AGENDA

AUGUST 28, 2023

1. Professional Service Agreement - Engage Westerman Construction, Co., Inc. -
St. Paul's Additional Services.

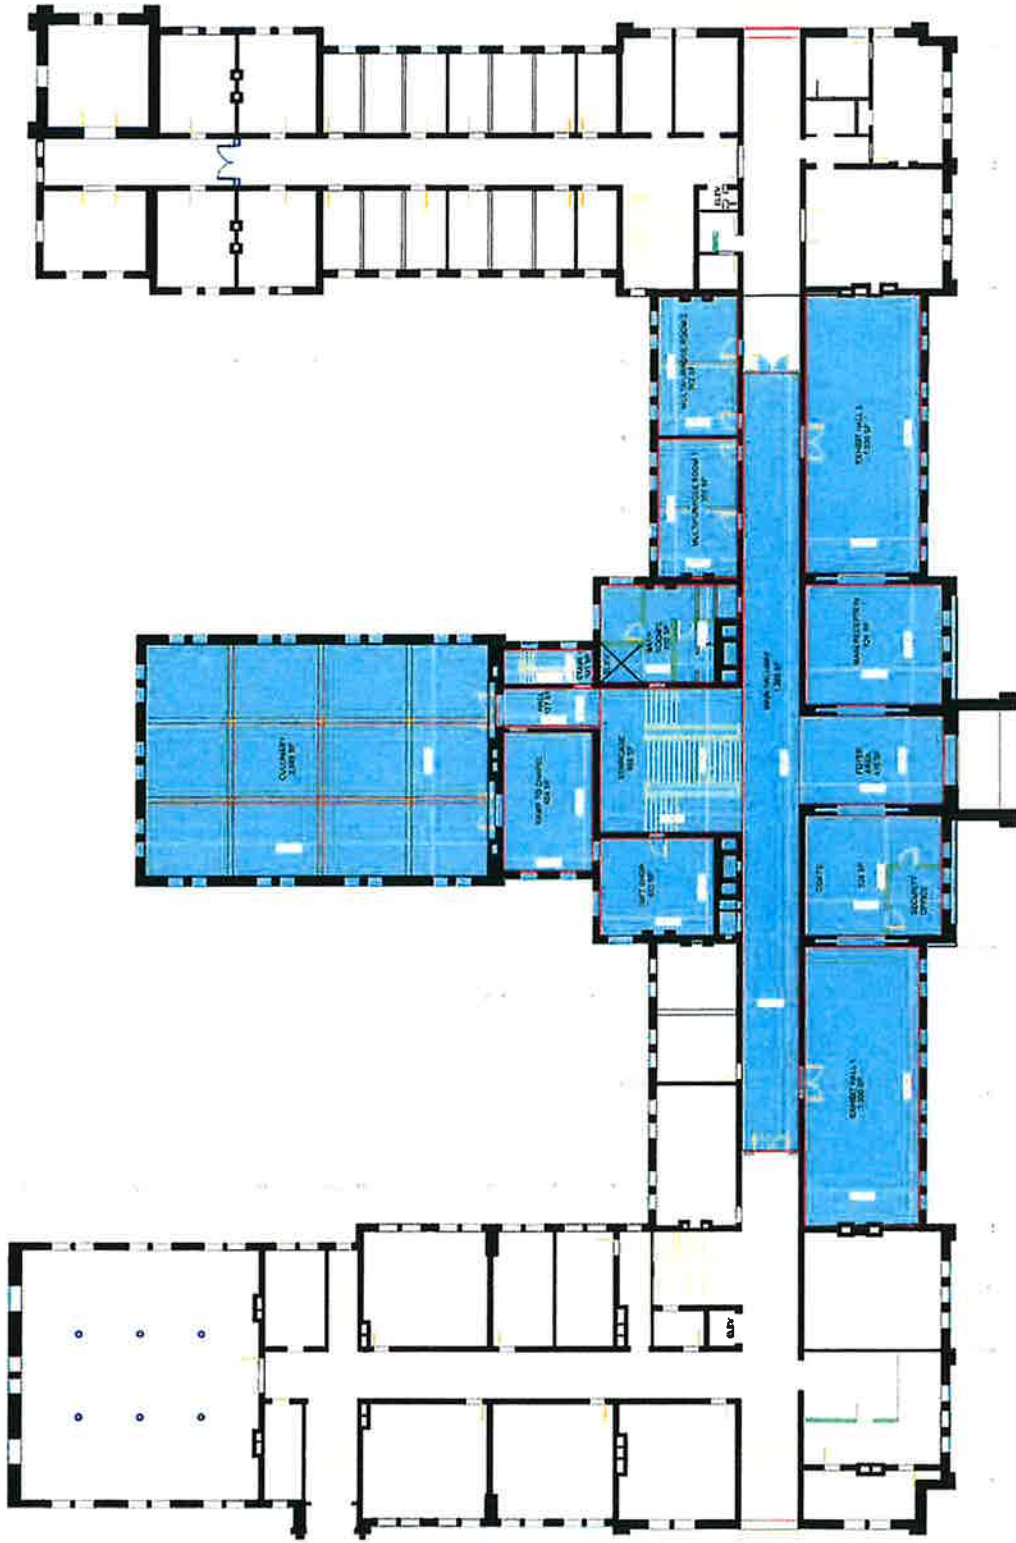
3) I have attached A101 – FIRST FLOOR PLAN and A102 -SECOND FLOOR PLAN as provided by Giuseppe Giovanniello.

Giuseppe's 1st and 2nd Floor Exhibits correspond to the light blue shaded areas of the Will Alise diagrams A101 and A102 labeled Community Center. The Will Alise drawings appear on our Village website at the following link:
<https://www.gardencityny.net/291/St-Pauls>

The Will Alise diagrams are currently referenced in your June 14, 2023, Comparative Analysis a few times and in different ways as identified the Westerman Reports Comment document attached. Including the Will Alise diagrams as an Exhibit we believe will add confusion to the Report but the A101 and A102 Floor Plan Exhibits created by Giuseppe's instead isolates and highlights the Phase 1 areas of the Adaptive Reuse option. Please concur and use these Exhibits or instead create your own Exhibits that correlate to the Phase 1 area estimated in this option within the Report.

- ii. For each floor add Exhibits that clearly highlight the work to be included in each option. The exhibits should reflect work related to demolition, stabilization, and finished space (including square footage). We are including exhibits that were put together by Building Superintendent Giuseppe Giovanniello. We would like concurrence that the areas in blue are the areas that are priced out in Phase 1 (or not). Can you either approve of the exhibits or replace them with your own exhibits that correspond to the adaptive reuse Phase 1 pricing in your report. For Facadism, please reflect interior finished space (if any) that was contemplated, as well as a plan view of the final structure so folks are clear what is included in the estimate cost.
